ICC A117.1 Committee Action Report

Proposal list to the 2017 A117.1 for the 2023 edition –
2-24-2022 through 1-19-2023
Chapter 1 to 5

Proposed overlap allowance

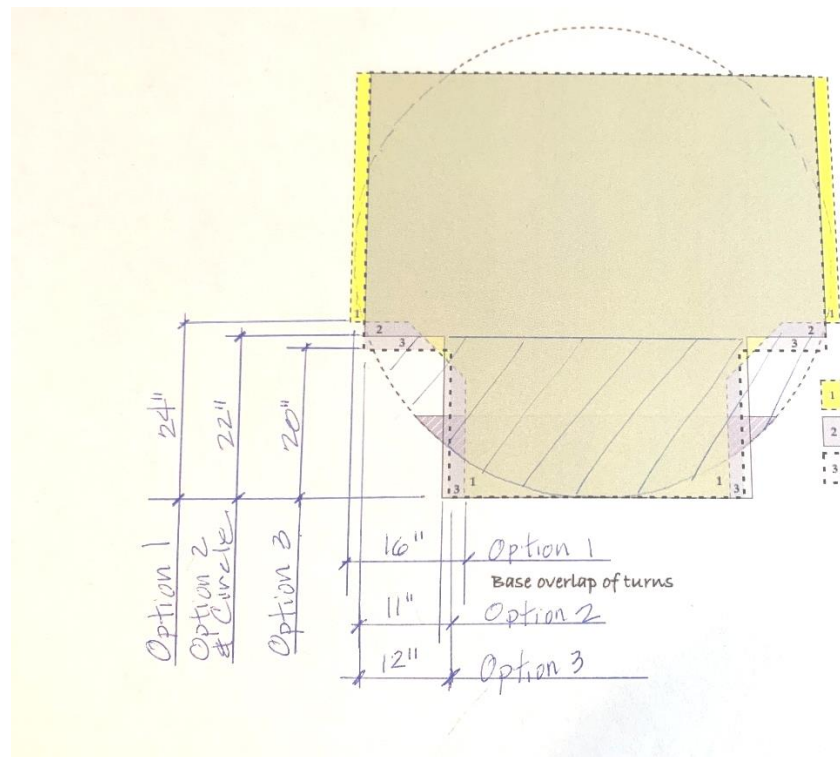
REASON: The purpose of this proposal is to coordinate the overlap allowances for turning spaces. The A117.1 decided not to change the knee and toe clearances between the 2009 and 2017 edition. The turning spaces have increased in size and substantially limited the overlap at the same time. Since the circle and T-turn are to turn 180 degrees, they should be consistent – while now there are substantial differences in all 4 options. With the larger turning space, these proposals will still be a reduction on the total percentage of the turning space permitted under the

FIGURE 405.9.2.2

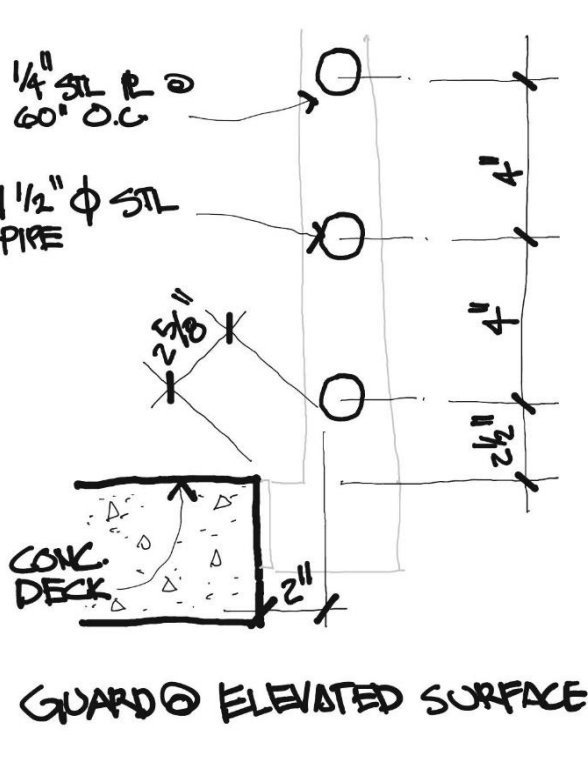
Staff note: Direction is required for changes to Figure 405.9.2.2.

Reason: To clarify some issues that may arise with where the edge protection would be required that would be problematic.

Report for 04-02- 2021		
Committee decision: D	Committee Vote at Meeting: 28-0-3	Committee Vote on Ballot:
REPORT OF HEARING:		
Modification (if any):		
Committee Reason: Adding edge protection at the locations indicated raised concerns about the potential for tripping hazard for non-wheelchair users. Issues with guards should be addressed in the building code since they are not required in ICC A117.1. code. The proposed language is not clear for if this requires a curb or railing; and the extent of where this would be required is not clear.		
PUBLIC COMMENT- FIRST DRAFT:		
Proponent:		
Desired Action:		
Modification:		
Reason:		
Committee decision: AS/AM/D	Committee Vote at Meeting:	Committee Vote on Ballot:
REPORT OF HEARING – FIRST DRAFT		
Modification (if any):		
Committee Reason:		
PUBLIC COMMENT- SECOND DRAFT:		
Proponent:

FIGURE 406.3(A)
PARALLEL CURB RAMP

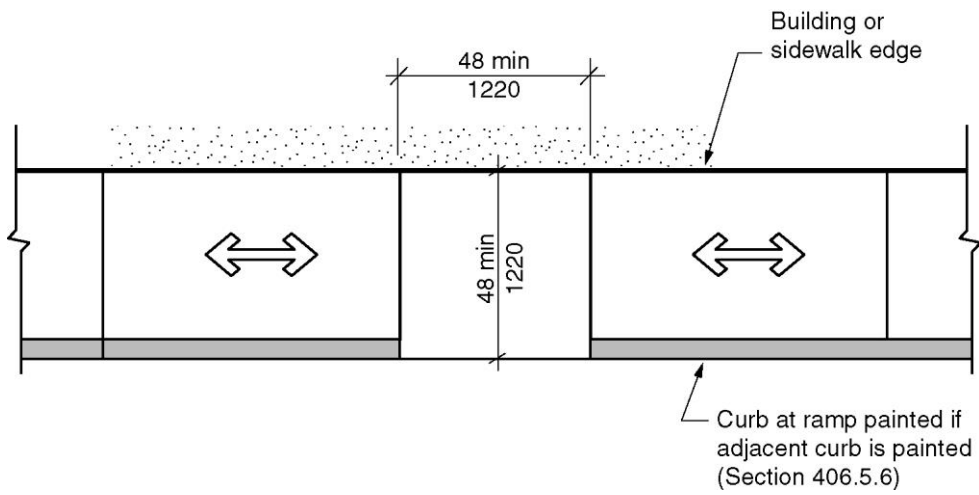
REASON: Curb ramps are not complete without detectable warnings. While there is a section showing detectable warnings on curb ramps in some detail, they should not be omitted here. It implies that they are not required. Wherever curb ramps are depicted, unless they are not required to have detectable warnings, as in Figure 502.9.1, the detectable warning should be included. Figure 502.9.1.2 correctly includes the detectable warning, even though it is in Section 502 Parking Spaces.

Committee Reason: The first modification was approved because the committee felt that it was important to clarify that detectable warnings were only required in limited situations, thus the addition of the note in each drawing. The 2nd modification was approved to remove the original proposal’s suggestion to show the detectable warning on each curb cut. The committee felt that many people just looked at the pictures rather than the text, so showing the detectable warnings

**FIGURE 502.9.1
WIDE SIDEWALKS**

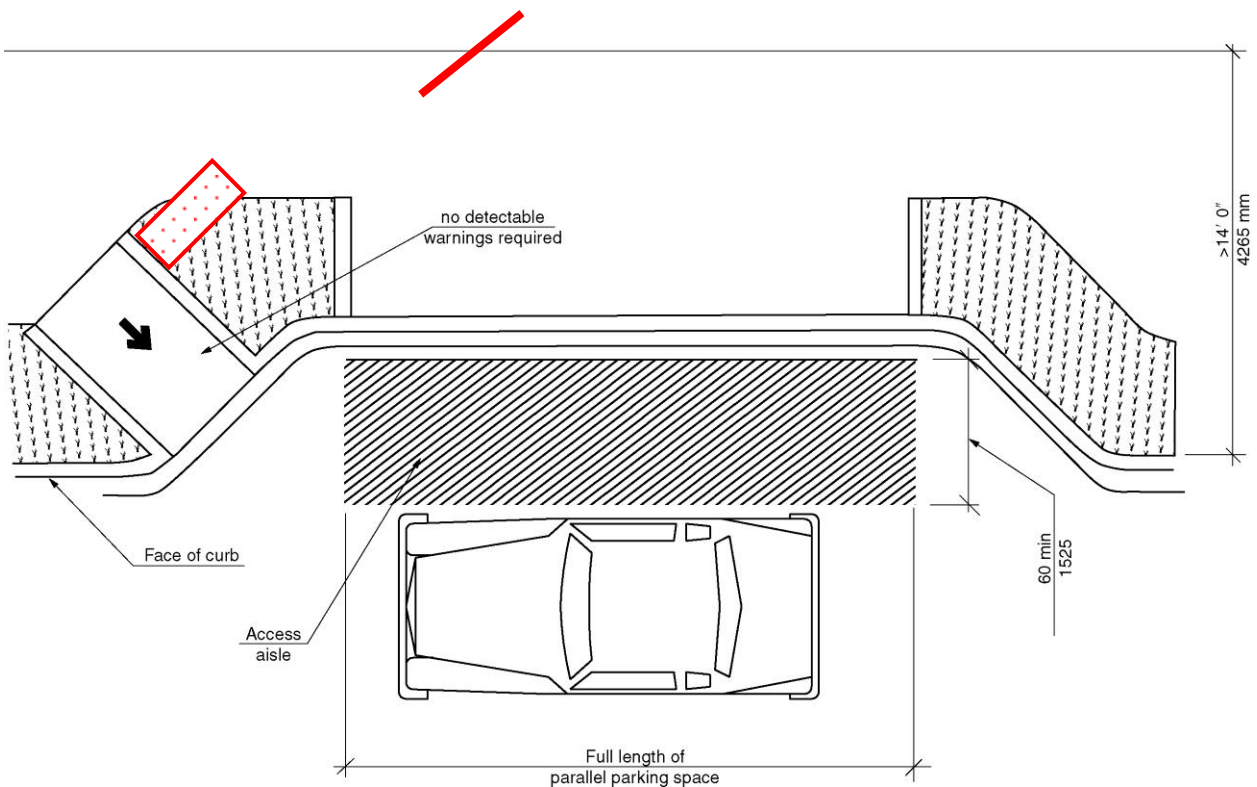
Note: The curb ramp in this figure should show detectable warnings.

REASON: Curb ramps are not complete without detectable warnings. While there is a section showing detectable warnings on curb ramps in some detail, they should not be omitted here. It implies that they are not required. Wherever curb ramps are depicted, unless they are not required to have detectable warnings, as in Figure 502.9.1, the detectable warning should be included. Figure 502.9.1.2 correctly includes the detectable warning, even though it is in Section 502 Parking Spaces.

**FIGURE 503.3(A)
PASSENGER LOADING ZONE ACCESS AISLE - NEW BUILDINGS**

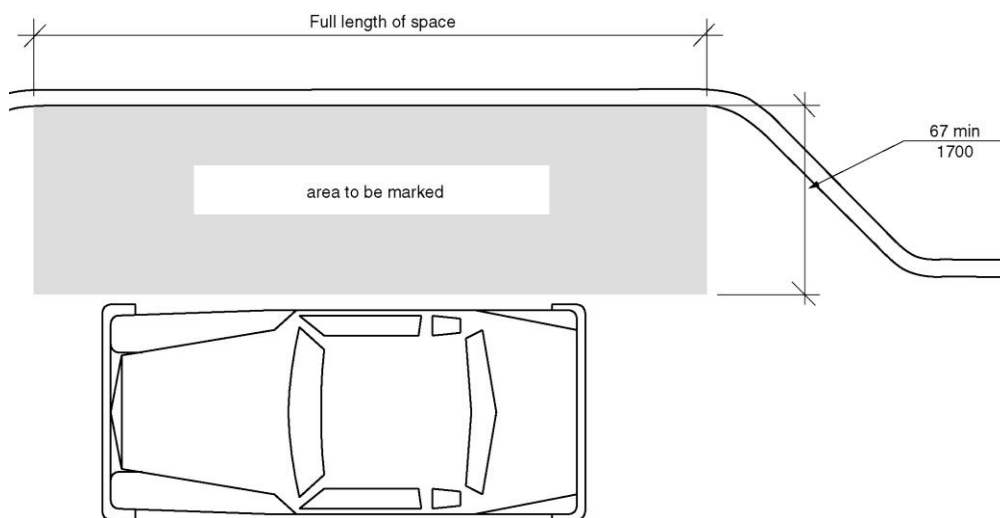
Note: Add curb ramps

FIGURE 607.5.1
LOCATION OF BATHTUB CONTROLS ON BACK WALLS

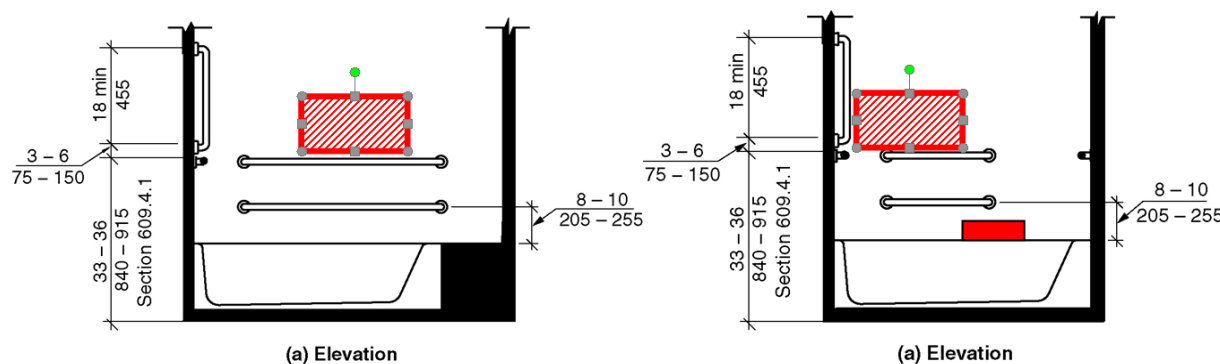
Note: Add two new figures with dimensions to match text for rear wall controls.

FIGURE 607.5.1
LOCATION OF BATHTUB CONTROLS DIVERTERS AND MOUNTS ON BACK WALLS

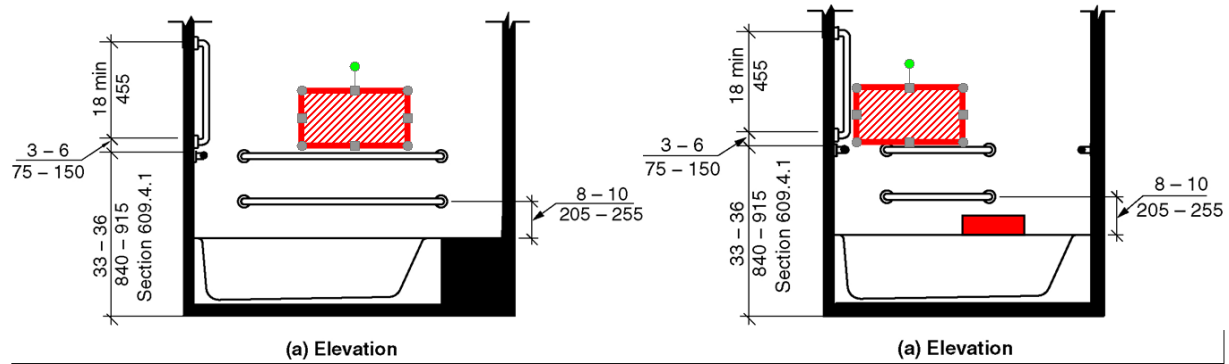
Note: Add two new figures with dimensions to match text for rear wall controls.
